**CERTIFICATE OF APPROPRIATENESS**

**Property:** 1808 Kane St, Lot 7, Block 443, Baker W R NSBB Subdivision. The property includes a historic 1,755 square foot, one-story wood frame multi-family residence situated on a 5,000 square foot (50' x 100') interior lot.

**Proposal:** Alteration –

**Recommendation: Partial Approval:**

SOUTH ELEVATION – FRONT FACING KANE STREET

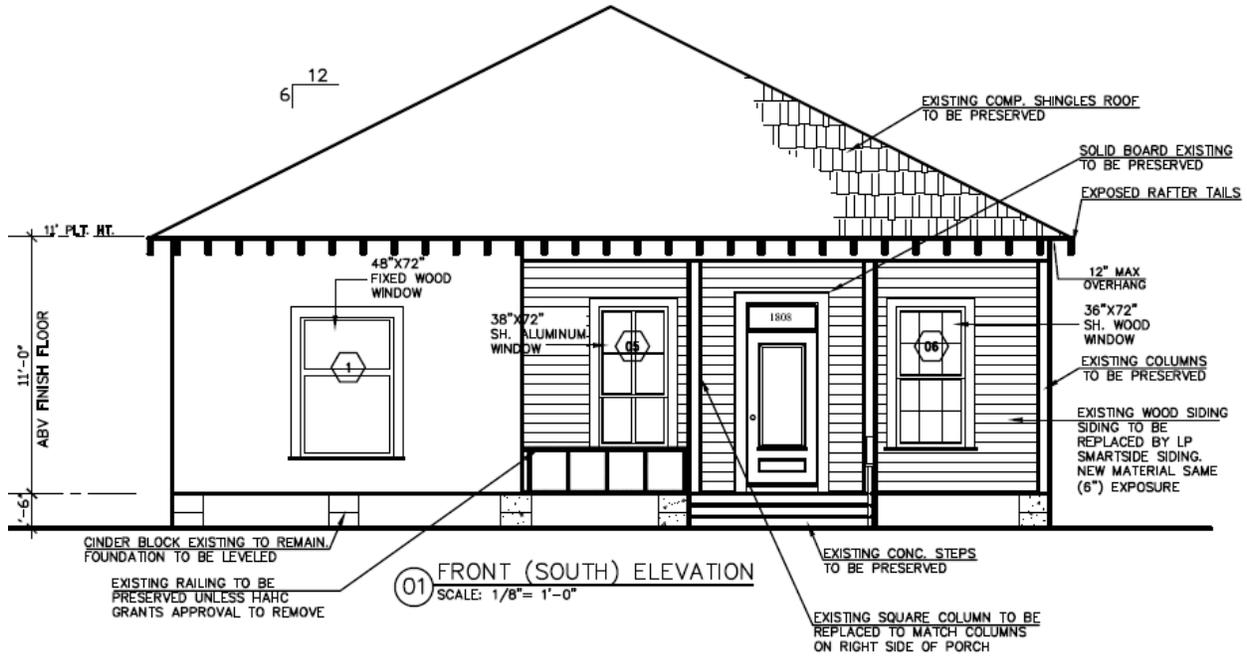
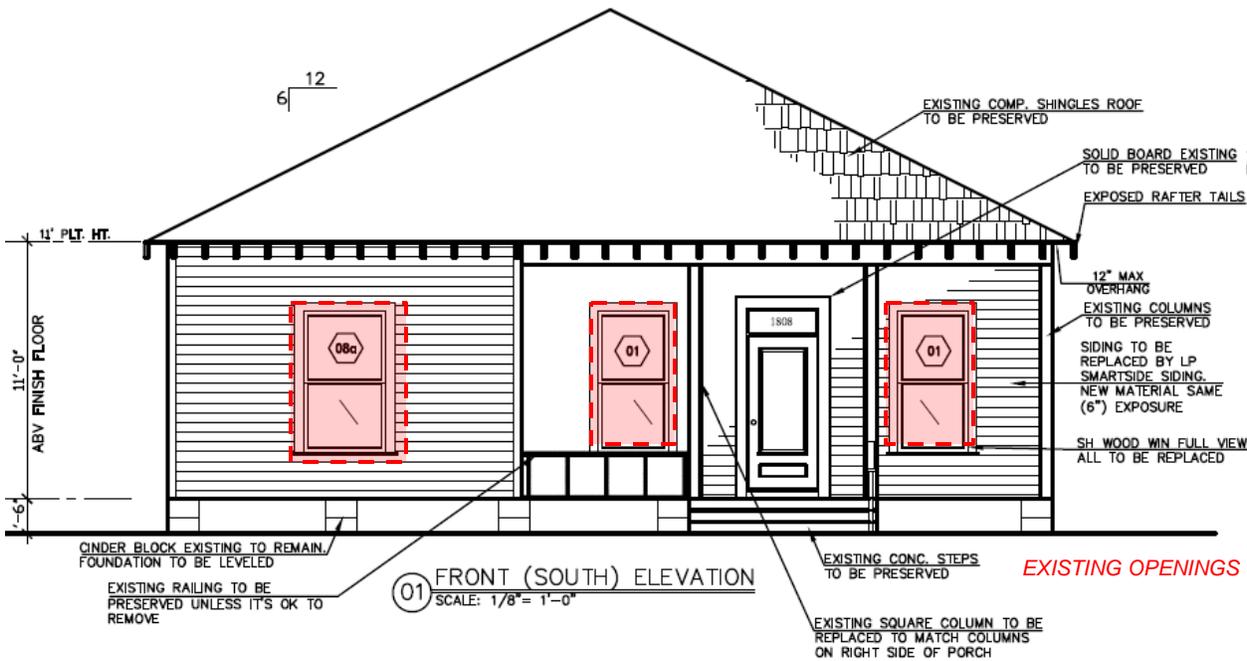
|                                     | <input checked="" type="checkbox"/> | <input type="checkbox"/> | (1) The proposed activity must retain and preserve the historical character of the property;<br><i>The removal of the historic siding and windows and relocation and resizing of the window openings destroys historic material and configuration of the windows. Therefore, the alteration does not retain the historical character of the property. If the historic windows and openings and siding were retained, the project would meet criteria.</i>  |

**Front Elevation:** The existing residence contains a fixed 1-over-1 wood window, a multi-divided lite aluminum window and a wood 6-over-6 window with the bottom sash missing. The alteration replaces all windows with wood 1-over-1 windows and reduces the fixed window from 48" wide to 42" wide, and reduces the aluminum window from 38" to 36" wide.  
**(South)**

- **Windows: Approval to replace aluminum windows with 2-over-2 wood windows to match original within existing openings; approval to replace wood 6-over-6 windows with wood 2-over-2 windows in existing openings; approval to replace door on west side with 2-over-2 window in existing opening. Denial to relocate or alter the size of any window openings.**
- **Denial to replace all wood siding with composite wood siding. Damaged existing wood siding should be repaired and replaced with like material following staff inspection.**
- **Approval to remove the rear addition and build rear deck and pergola.**

EAST SIDE ELEVATION

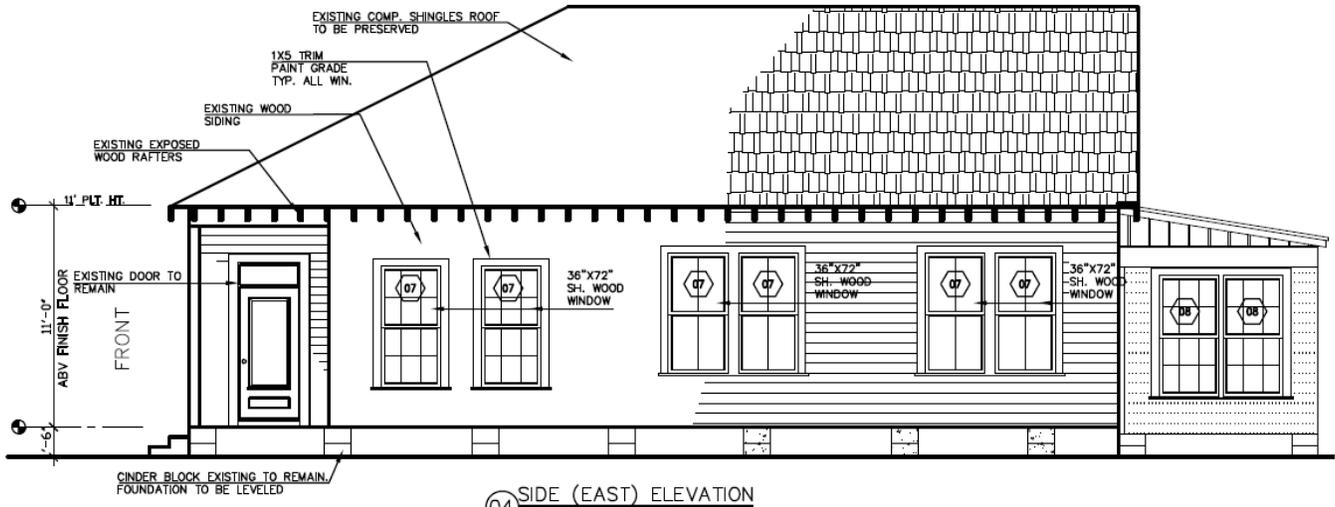
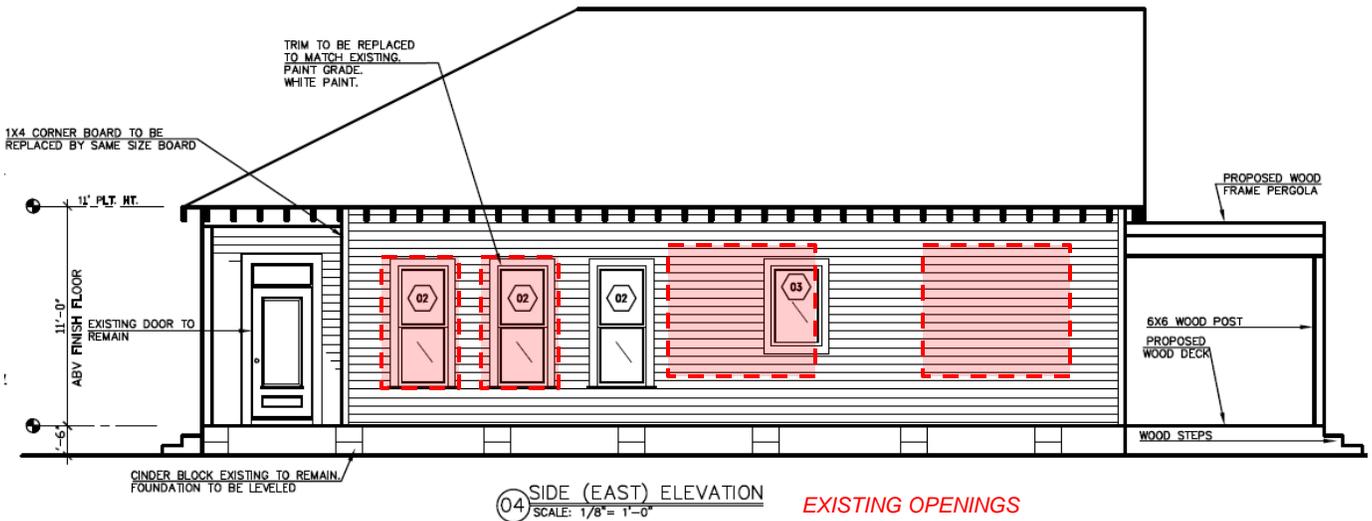
**Side Elevation:** The existing residence contains two wood 6-over-6 windows and four 2-over-2 wood windows.  
**(East)** The alteration replaces the 6-over-6 windows with 1-over-1 windows, removes the 2-over-2 windows and installs a 1-over-1 window in a non-original opening and a fixed window in a non-original opening. The alteration also changes the width of the 6-over-6 windows from 36" to 30".

WEST SIDE ELEVATION

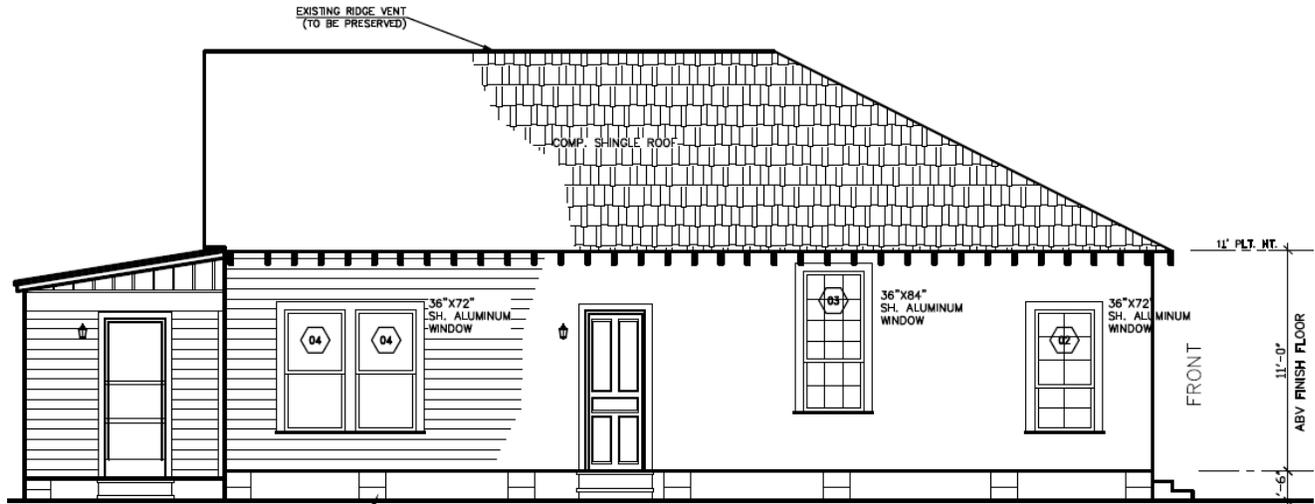
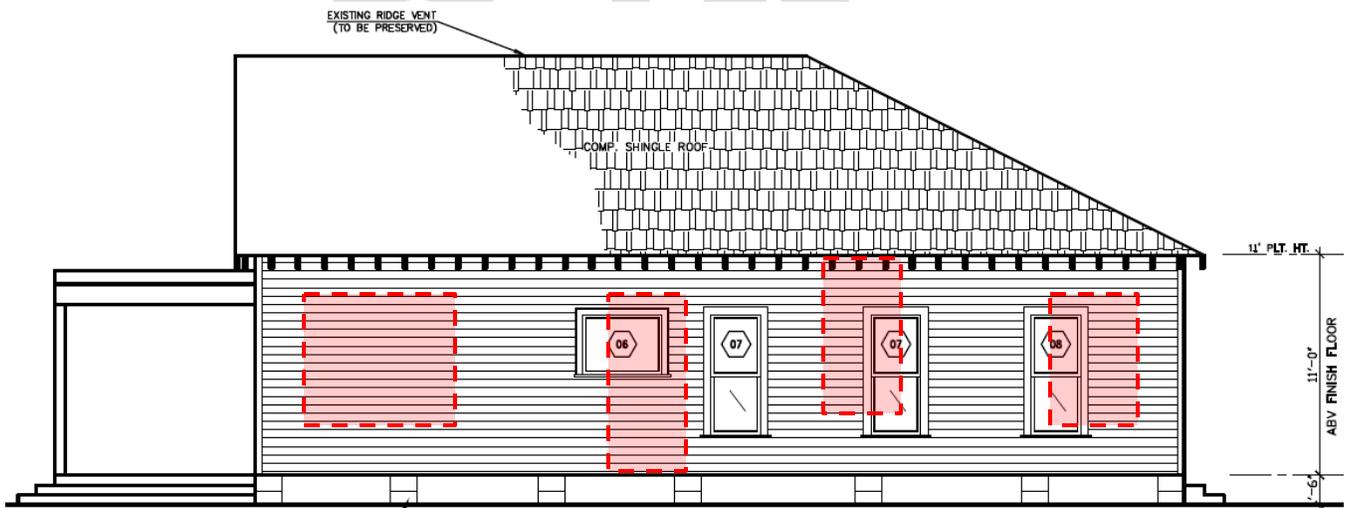
*The horizontal fixed window on the west elevation does not comply with the guidelines.*

**Side Elevation:** The existing residence contains two multi-divided lite aluminum windows, two 1-over-1 aluminum windows and a wood door and a wood door on the rear addition. The alteration relocates all window openings, removes the door and replaces the windows with wood 1-over-1 and one fixed window. The alteration also removes the rear addition.  
**(West)**

### NORTH (REAR) ELEVATION

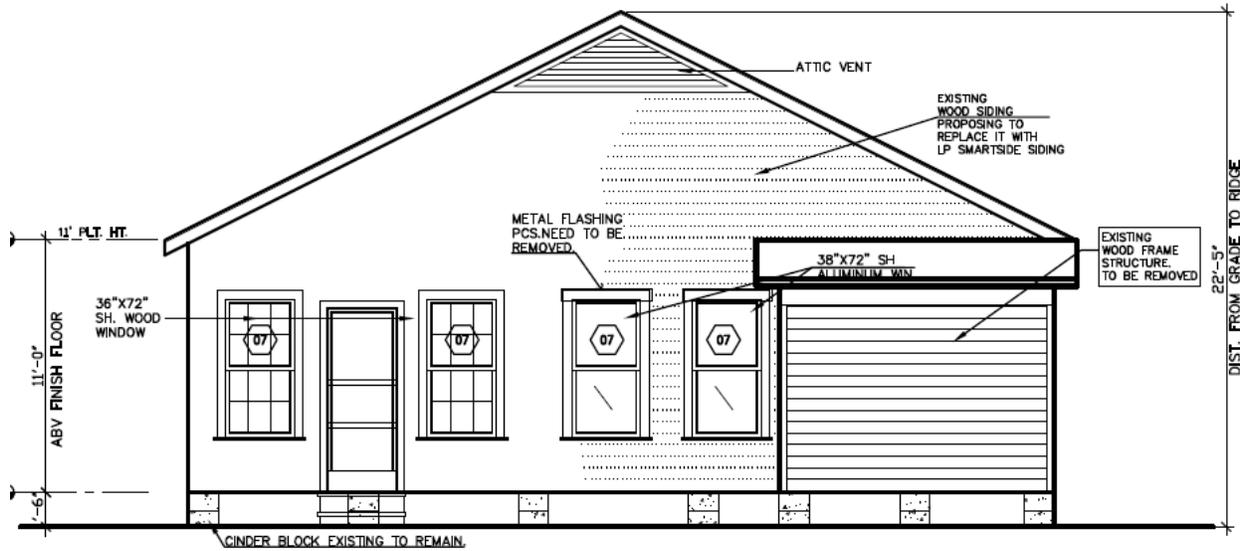
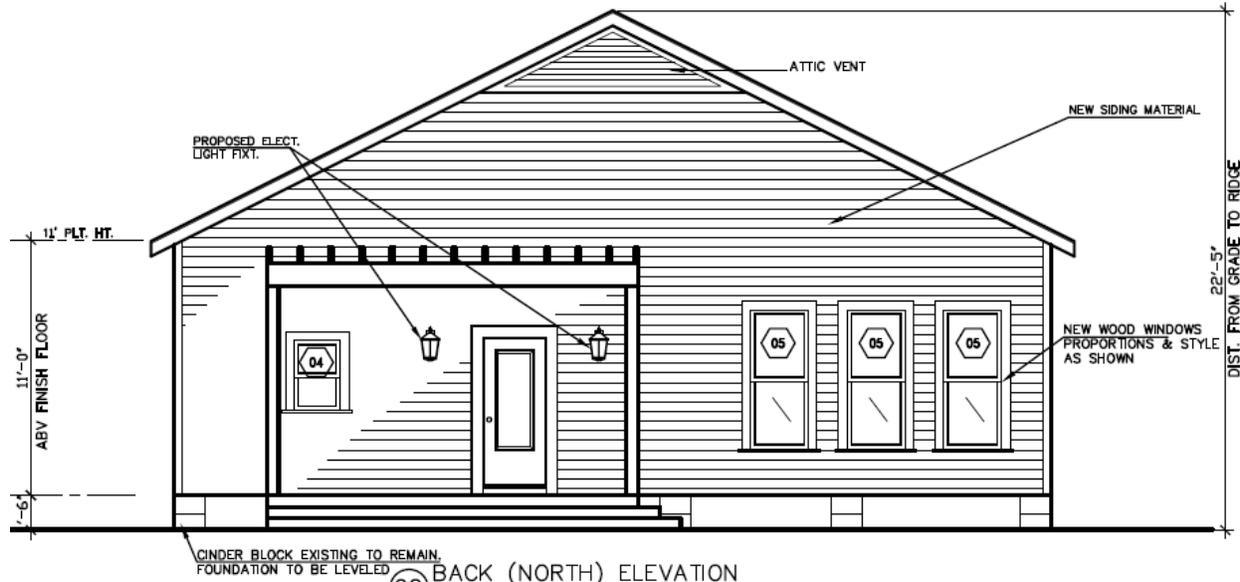
**Rear Elevation:** Not visible from public right-of-way.  
**(North)**
